AGENDA

ORDINARY COUNCIL MEETING

Tuesday, 10 September 2024

An application has been received for the use and development of land located at 345-347 Westbury Road, Prospect Vale ('the site' - refer to Figure 1).

Figure 6: Extract of amended site plan submitted by applicant.

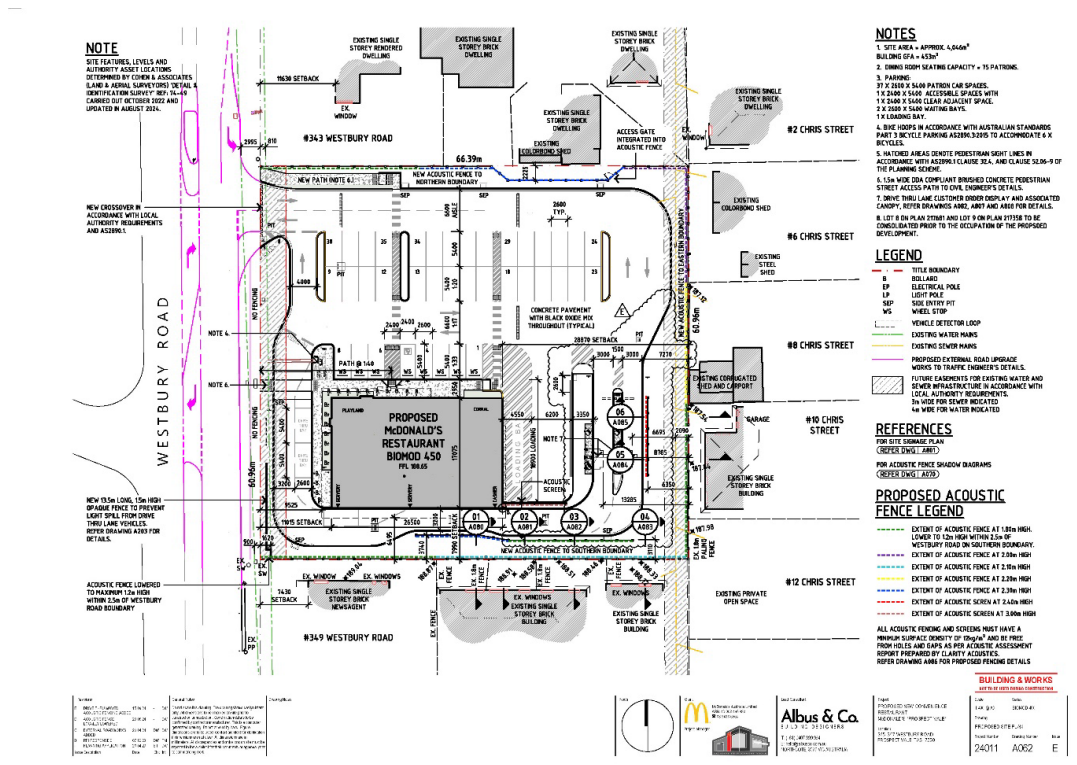
The amendments proposed are described in the table below. Please refer to Figure 6 for an extract of the site plan:

For the purpose of the assessment, the compliance table for the Acceptable Solution will consider both the advertised plans and the proposed amendments.

Figure 7: Extract of site plan showing details of fencing.

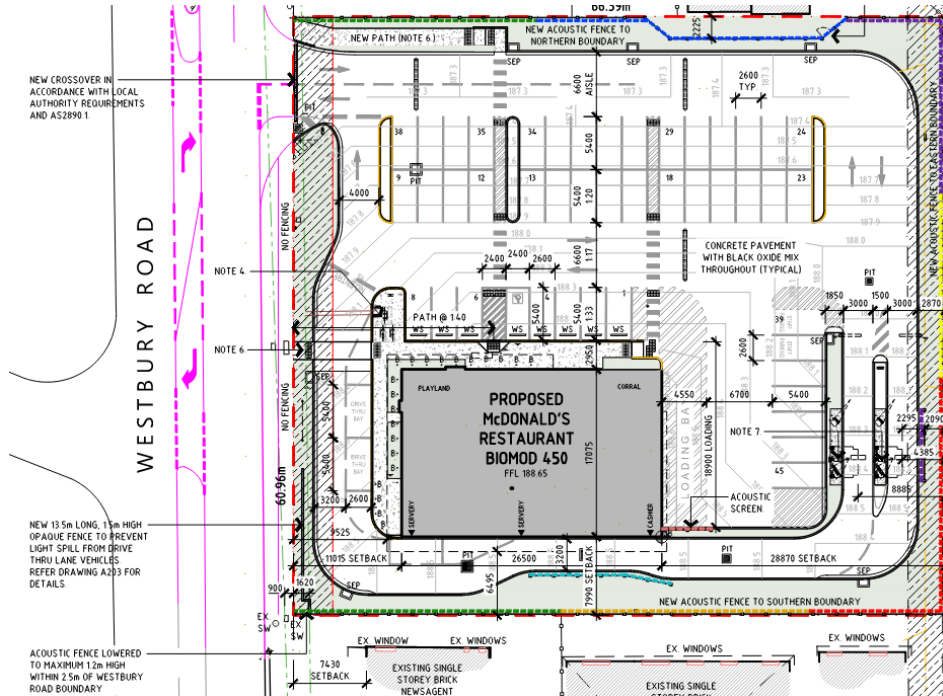
<i>Scheme Standard</i>	Planner's Assessment	Assessed Outcome
	<p>Acoustic fences are also proposed to the northern and southern boundary of the site and will also be within 4.5m of the frontage (Westbury Road). These fences will be solid acoustic fences having a maximum height of 1.8m.</p> <p>These fences do not comply with the frontage fence exemption.</p> <p>Refer to Figure 6 and 7 below showing the proposed fencing.</p>	
A2	<p>Acoustic fences are proposed along the common boundary with properties in the General Residential zone and beyond 4.5m from the frontage. These fences range in height from 1.8m to 2.6m, noting that the overall height is higher in some sections due to a retaining wall required establish the finished surface level. The acoustic fences will be constructed on top of the proposed ground level. The overall maximum height for the acoustic fence is 3.015m</p> <p>All proposed common boundary fences that exceed 2.1m do not comply with the Acceptable Solution. Refer to Figures 7 and 8 below.</p>	Relies on Performance Criteria

Figure 9: Extract of amended site plan to show amended fencing detail.

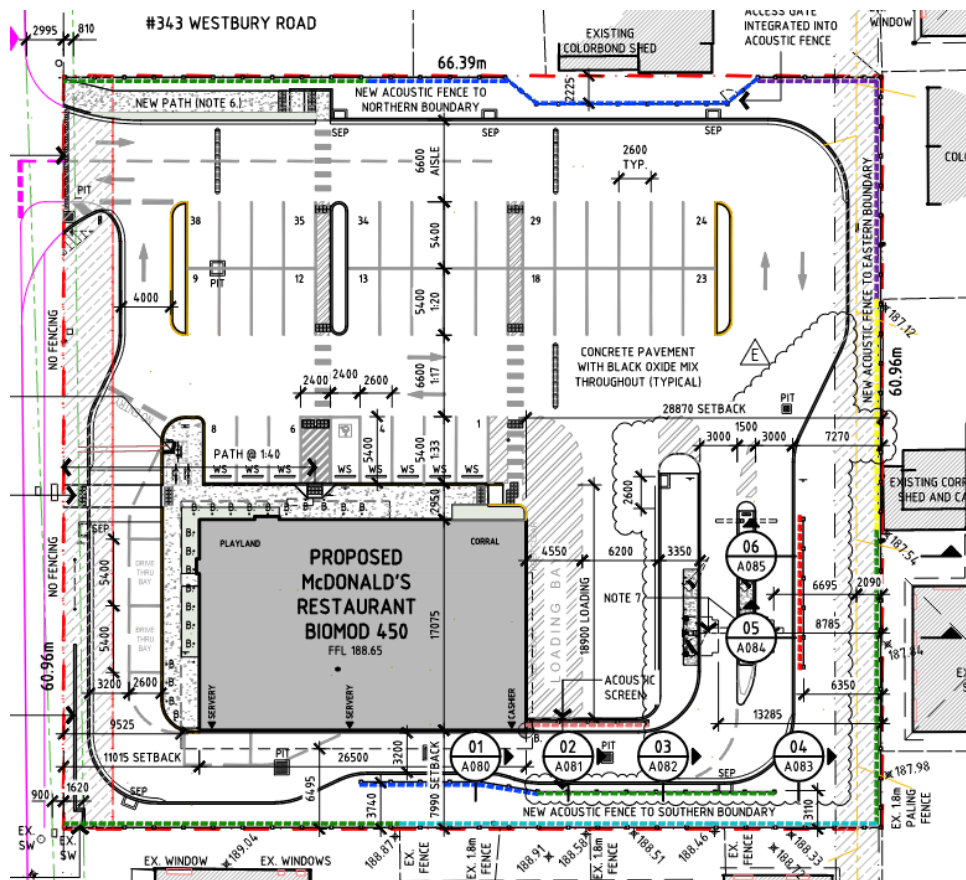
Figure 9 and 10 show the extract of the amended site plan to demonstrate the proposed fencing.

Figure 11: Swept path assessment showing queuing spaces within the drive through. (Source: Traffic Impact Assessment).

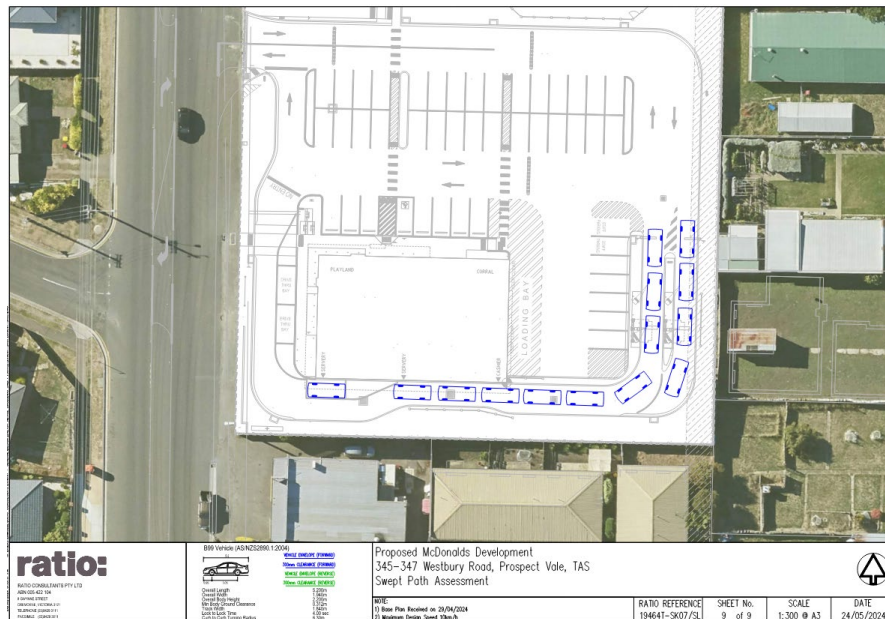
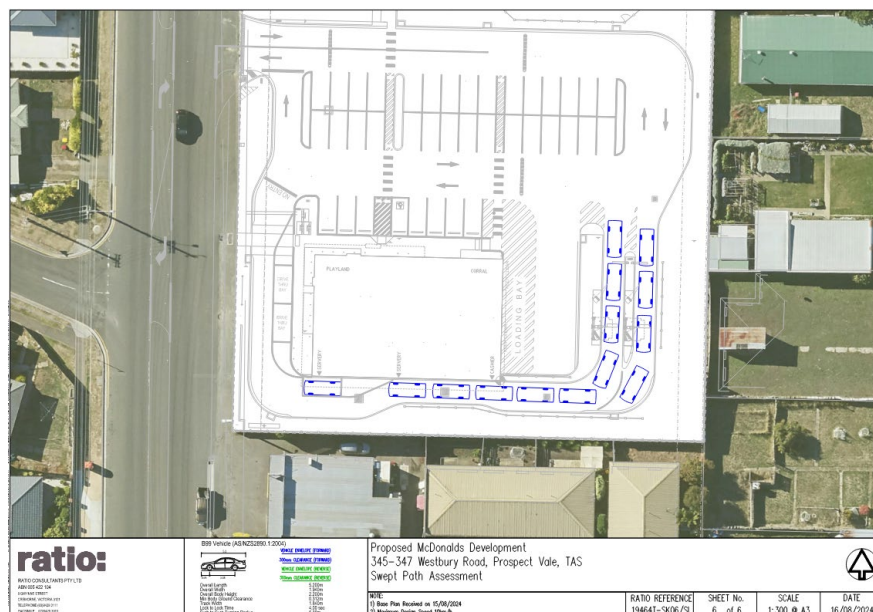
The queuing ability for cars within the drive through will not change as a result of the amendment. Refer to Figure 11 and 12 below.

Figure 5: Electrical Services, Lighting, General Arrangement. Source: Rubidium Light 2024:9)

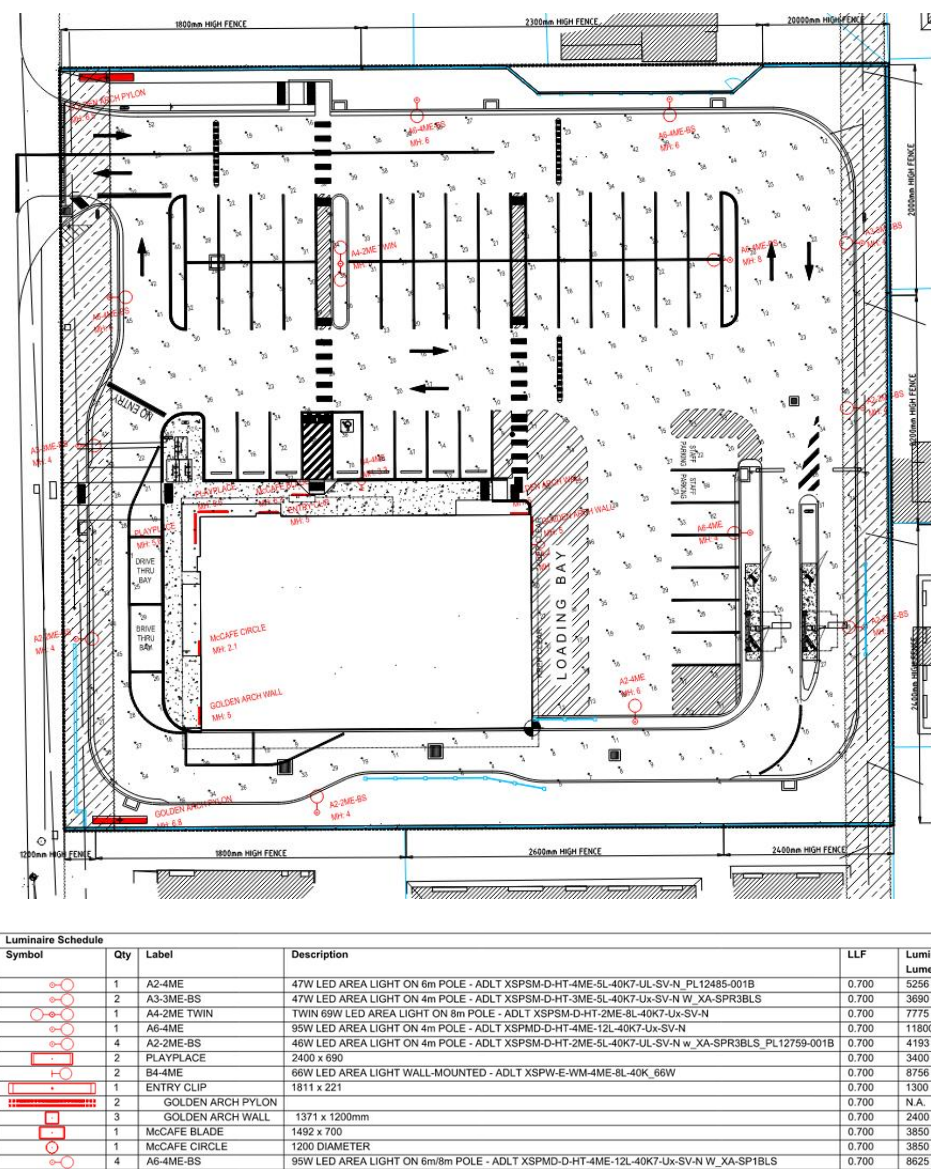
Scheme Provision	Planner's Assessment
15.3.1 Performance Criteria P2	<p>The proposed development will require external lighting to light the car park, circulation spaces and drive through. The external lights will operate outside the nominated hours in the Acceptable Solution and therefore the application relies upon the corresponding Performance Criteria (P2) to demonstrate compliance with the Standard.</p> <p>The two pylon signs and some signage are also proposed to be illuminated. Clause C1.6.2 – Illuminated signs of the Signs Code provides a specific provision for illuminated signs. Therefore, the proposed illuminated signs will not be considered in the assessment of this provision (15.3.1 A2 & P2) as the signs code appropriately assesses the illumination and is considered to prevail.</p> <p>The site adjoins the General Residential Zone and it must be demonstrated that the external lighting for the Food Services use must not cause an unreasonable loss of amenity to the residential zone having regard to:</p> <ul style="list-style-type: none"> (a) the level of illumination and duration of lighting; and (b) the distance to habitable rooms of an adjacent dwelling.

Scheme Provision	Planner's Assessment
	<p>The lights have been selected to direct light onto the subject site, with minimal spill outside the boundaries and have zero upward light component. The lights located on the site boundary are to be fitted with backlight shields to cut off light emitted in the directions of dwellings (Rubidium Light 2024:7 – Version 7).</p> <div data-bbox="440 586 1445 801"></div> <p><i>Figure 4: Cross-section of the site from Westbury Road demonstrating the height of light poles. Source: Rubidium Light 2024:10)</i></p>

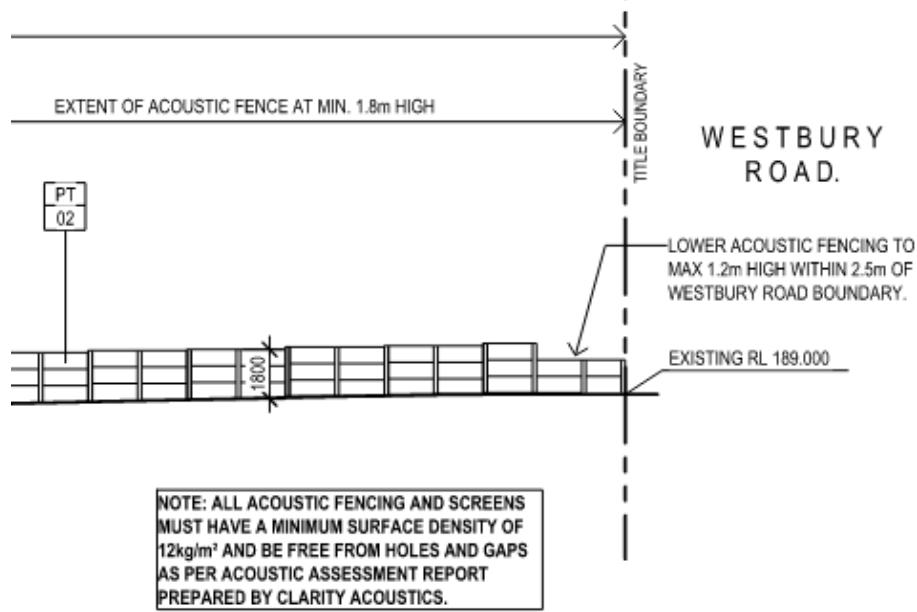
Scheme Provision	Planner's Assessment							
	<div></div> <p>Figure 9: Excerpt of the southern acoustic fence elevation. Source: Application documents.</p>							
15.4.4 Performance Criteria P1(b)	Both the opaque fence and acoustic fences will be solid and not have any degree of transparency.							
15.4.4 Performance Criteria P1(c)	<p>The 1.5m high opaque fence will be a solid structure with a paint finish coloured wayward grey.</p> <table><tr><td>PT</td><td>02</td><td>MAIN BUILDING WALLS AND LOW HEIGHT WALL</td><td>PAINT FINISH. REFER SPECIFICATION FOR DETAILS ON PAINT TYPE & APPLICATION</td><td>DULUX</td><td>WAYWARD GREY PG1G8</td><td></td></tr></table> <p>Figure 10: Colour schedule for the opaque fence. Source: Application documents.</p> <p>The details regarding the material and construction for the acoustic fence are not stated in the application documentation. However, the acoustic fence must have a minimum surface density of 12kg/m² and be free from holes and gaps as per the acoustic assessment prepared by Clarity Acoustics. The applicant has verbally confirmed that the fence will be a solid timber structure.</p>	PT	02	MAIN BUILDING WALLS AND LOW HEIGHT WALL	PAINT FINISH. REFER SPECIFICATION FOR DETAILS ON PAINT TYPE & APPLICATION	DULUX	WAYWARD GREY PG1G8	
PT	02	MAIN BUILDING WALLS AND LOW HEIGHT WALL	PAINT FINISH. REFER SPECIFICATION FOR DETAILS ON PAINT TYPE & APPLICATION	DULUX	WAYWARD GREY PG1G8
